**EAST GOSHEN TOWNSHIP
PLANNING COMMISSION
Meeting Agenda
Tuesday, September 24, 2024
7:00 PM**

Date: September 18, 2024
To: East Goshen Township Planning Commission
From: Kelly A. Krause, Zoning Officer
Re: **1365/1373 Enterprise Drive**
Communications Test Design, Inc & Parsons 1365, LLC
Preliminary Land Development Plan

Re: East Goshen Township – Application of Communications Test Design, Inc. -
Preliminary Land Development Plans for One CTDI Place, dated April 29, 2024

**RE: PRELIMINARY LAND DEVELOPMENT PLANS (REVISED)
COMMUNICATIONS TEST DESIGN, INC. (CTDI)
1373 ENTERPRISE DRIVE, WEST CHESTER, PA 19380
EAST GOSHEN TOWNSHIP, CHESTER COUNTY, PA
CVE PROJECT # 22024-1000
PENNONI # EGOST 00142**

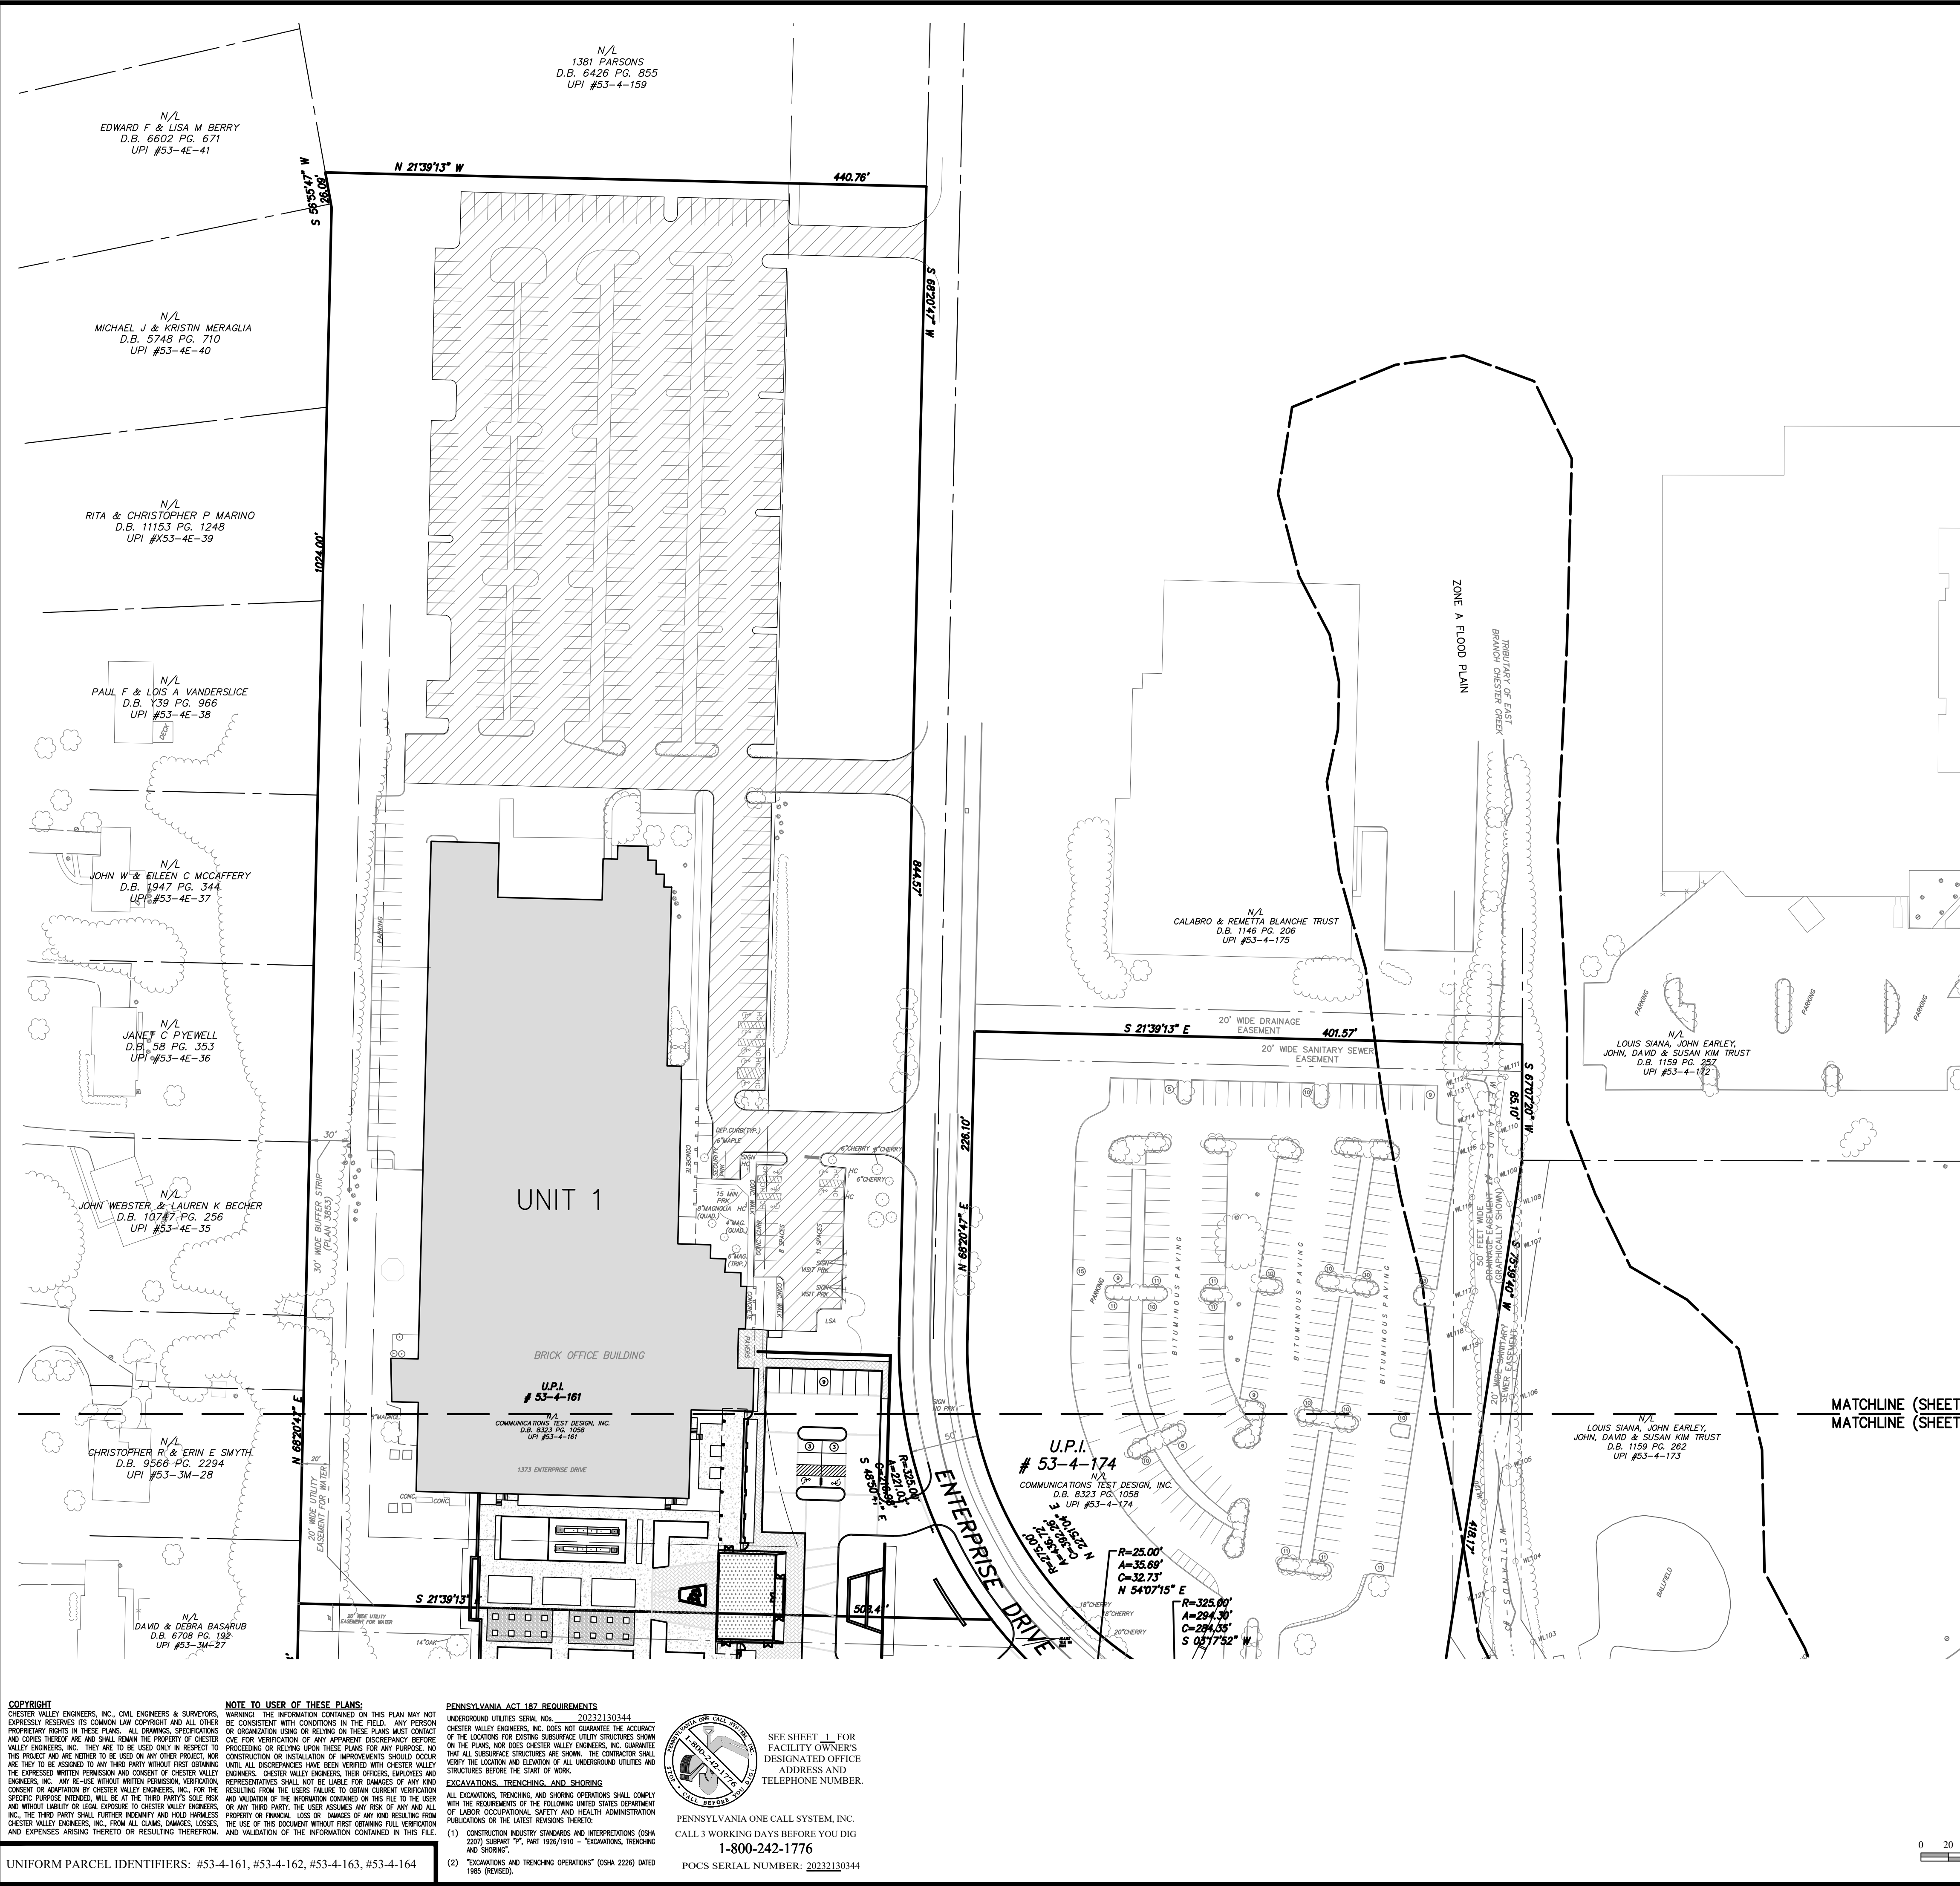
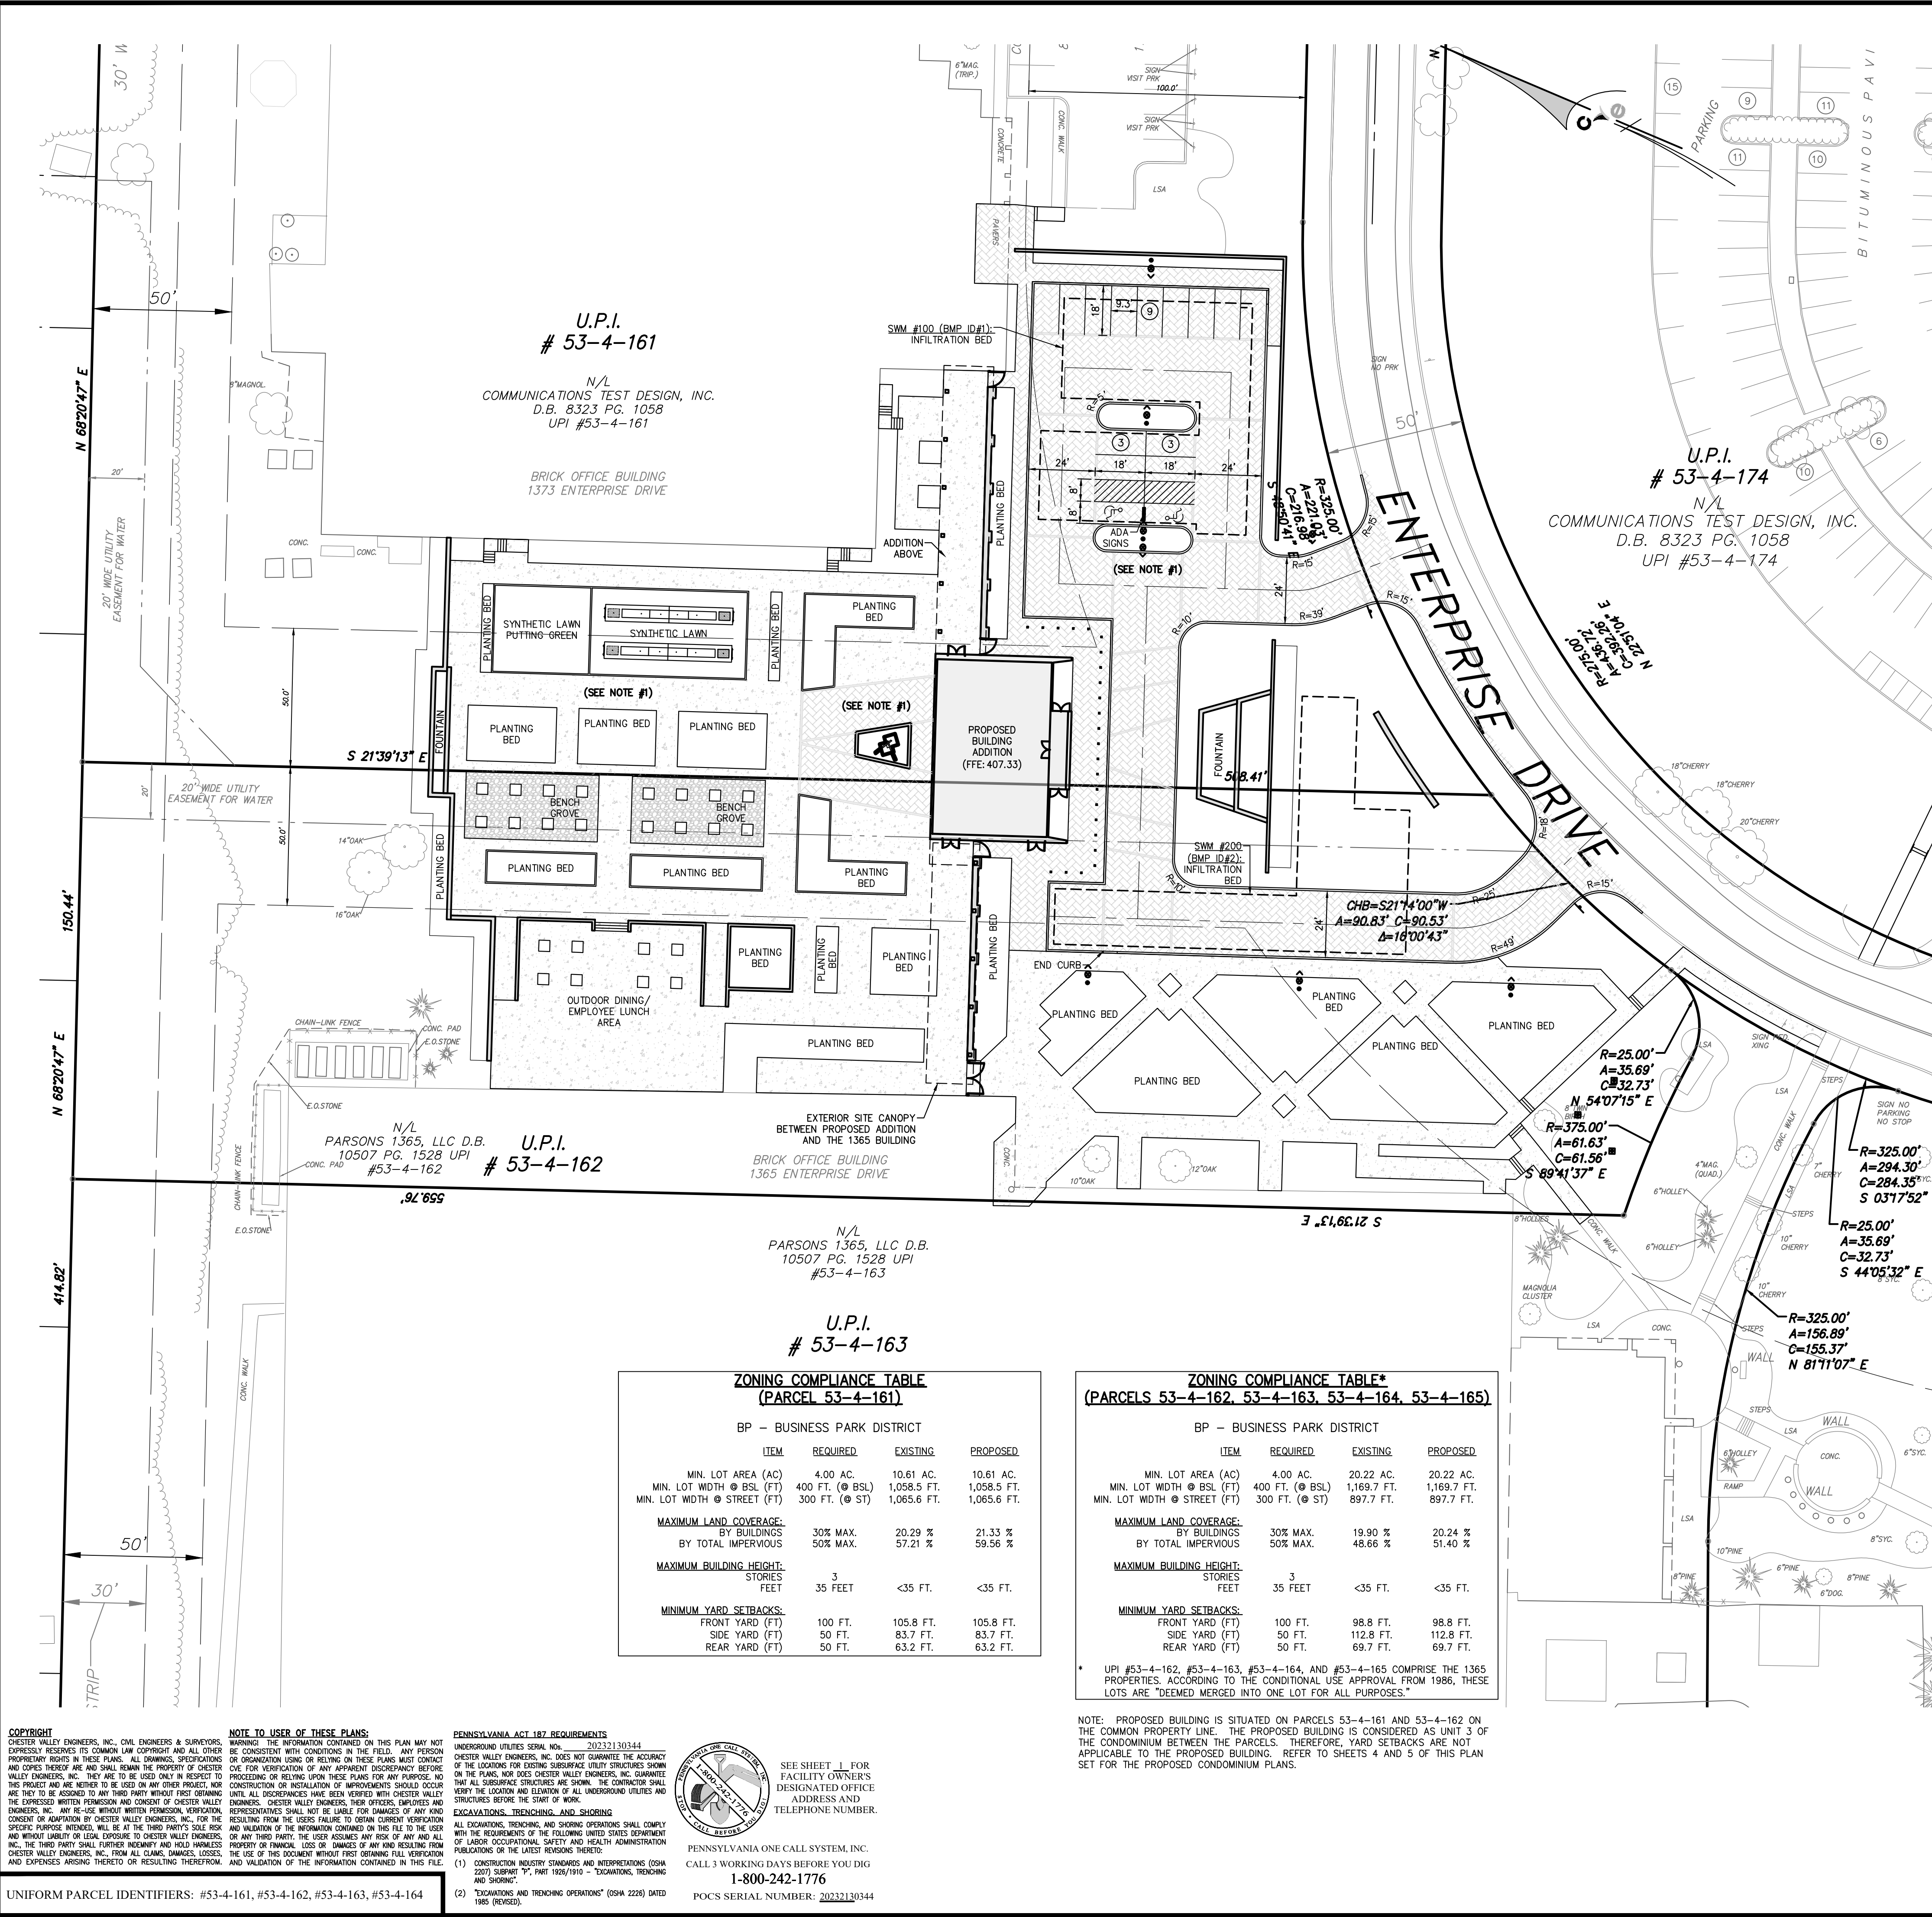
2. Review Comments to the Declaration of Condominium for One CTDI Place Condominium and the Condominium Plan (Sheets 4 and 5 of 17)
 - a. The Condominium Plan refers to the Property as Tax Parcels 53-4-161, 53-4-162, 53-4-163 and 53-4-164 and the Declaration refers to those parcels as well as Tax Parcel 53-4-174. The Property subject to the condominium should be consistently identified on Plan and Declaration. Exhibit A, which is blank, should identify the Property.

- b. All easements, licenses and agreements identified to be part of Exhibit C should be submitted for review before approval of the Plan.
 - c. Identify and describe each individual Unit in Section 3.2 of the Declaration by number. Section 3210 of the he Condominium Act provides that the dimensions of the units must be shown on the Plan.

- d. Provide that approval of the Township must be obtained for the relocation of boundaries and/or subdivision of units in Section 3.4 of the Declaration.

- e. Identify the Limited Common Elements for Units 1 and 2 shown on the Plan in Section 5.2 of the Declaration.
 - f. Provide that approval of the Township must be obtained for changes to Limited Common Elements.

- g. Section 6.1 provides for the creation of easements associated with the utilities, access, and structural support. Please provide details as to whether Section 6.1 creates these easements based on this language and whether these easements will be included in Exhibit C.

- h. Section 7.1 must be revised to provide that approval of the Township must be obtained for an amendment to the Declaration.
 - i. The Plans refer to a 1986 Conditional Use approval that merged the properties. This approval should be provided for review and inclusion on the Plan.
